# Groundwater Transfer Review Summary Form

Transfer/PA # T- 14788

Application: T-14788

Applicant Name: City of Sublimity

Hydrograph

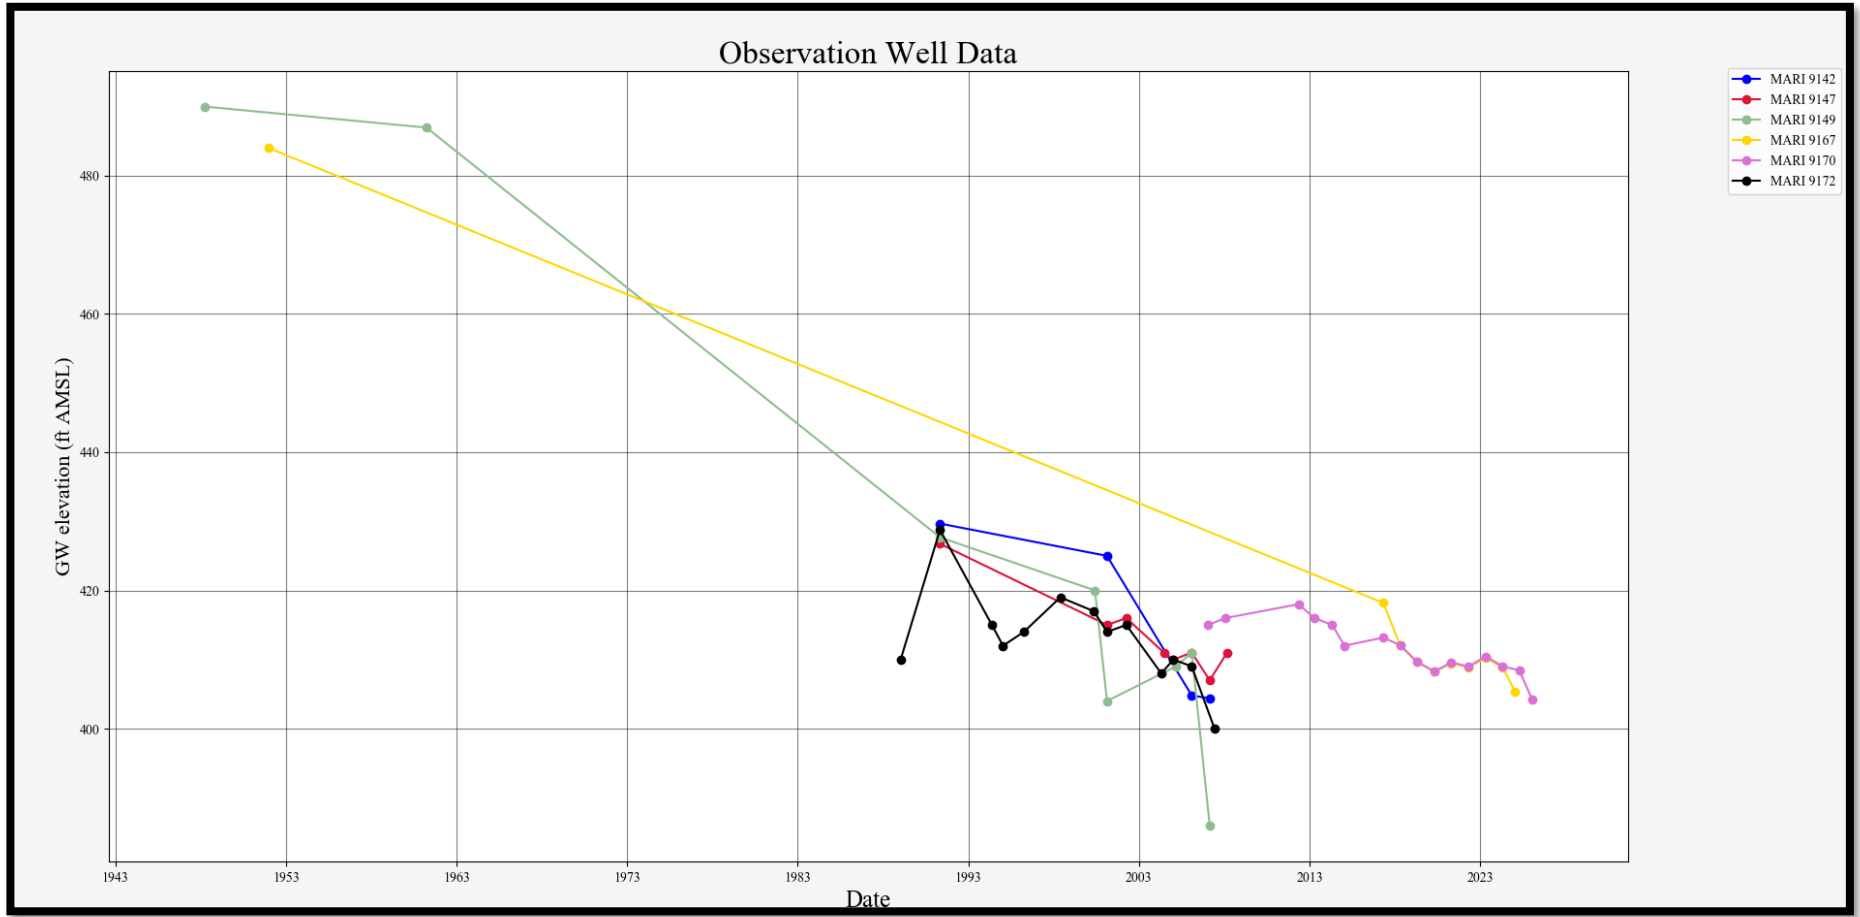
2. Will the proposed POA develop the same aquifer (source) as the existing authorized POA?  
 Yes  No Comments: The authorized and proposed POAs develop groundwater from multiple water-bearing zones, WBZs, within the Columbia River Basalt Group, CRBG (Gannett and Caldwell, 1998; Woodward et al., 198). Authorized POA 1/Well#3 (MARI 9147), develops a WBZ from 200 to 210 ft bls [332 to 342 ft amsl] with a most recent static water level, SWL, of 127 ft bls [415 ft amsl] in 2008. Authorized POA 2/Well#4 (MARI 91720, develops multiple WBZs 261 to 576 ft bls [74 to 389 ft amsl] with the most recent SWL of 243 ft bls [407 ft amsl]. The proposed APOA, Well #5 (MARI 9170/9160), develops three WBZs from 344 to 455.5 ft bls [94.5 to 206 ft amsl] with the most recent SWL of 145.83 ft bls [404.17 ft amsl] in 2026. Despite the differences in construction and elevations of WBZs, the SWLs are similar and these wells demonstrate an equilibration of WBZ heads such that the CRBG aquifer system now effectively behaves hydraulically as a single source (see attached Hydrograph). The APOA develops the same source as the authorized POA.

Theis Interference Analysis

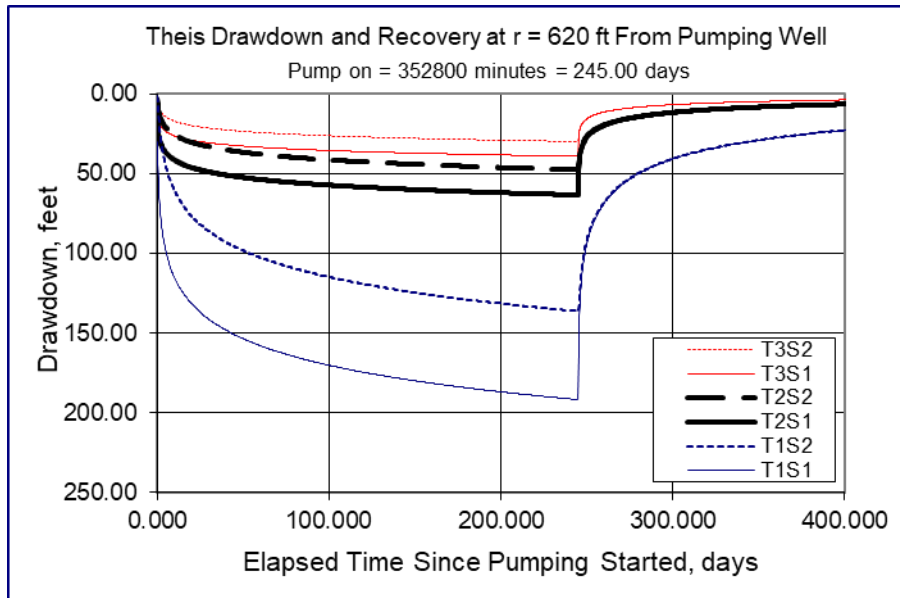
- b) If yes, would this proposed change, at its maximum allowed rate of use, likely result in another groundwater right not receiving the water to which it is legally entitled?  
 Yes  No If yes, explain: The Theis (1935) solution for drawdown was used to assess the potential for injury to MARI 9166 and MARI 9167 from the proposed changes (see attached Theis Interference Analysis). Pumping by the APOA, Well#5 (MARI 9170), is not likely to result in MARI 9166 or MARI 9167 not receiving the water to which they are legally entitled.

\*The max rates could not be used for the entire respective seasons of use because the maximum duties would be used up. The individual duties of 308.5 AF, 22.5 AF, 0.4 AF, and 13.5 AF could be used over the respective seasons of use at average rates of 0.426125 cfs, 0.0463 cfs, 0.000823 cfs, and 0.027781 cfs. Adding the subject water right rate of 0.2 cfs, the combined rate used is 0.70103 cfs (314 gpm).

SWL	84, 83	ft bls	MARI 9166, MARI 9167
Aquifer Bottom	470	ft bls	MARI 9170
Available Water Column	386 and 387	ft	Aquifer bottom-SWL
Pump Height Above Bottom	5	ft	Estimate
NPSHa	5	ft	Estimate
Drawdown	64	ft	Estimated from MARI 9166
Minimum Water Column	74	ft	Estimated Drawdown + NPSHa + Pump Height
Injury	312 and 313	ft	Available Water Column-Minimum Water Column for MARI 9166 and MARI 9167
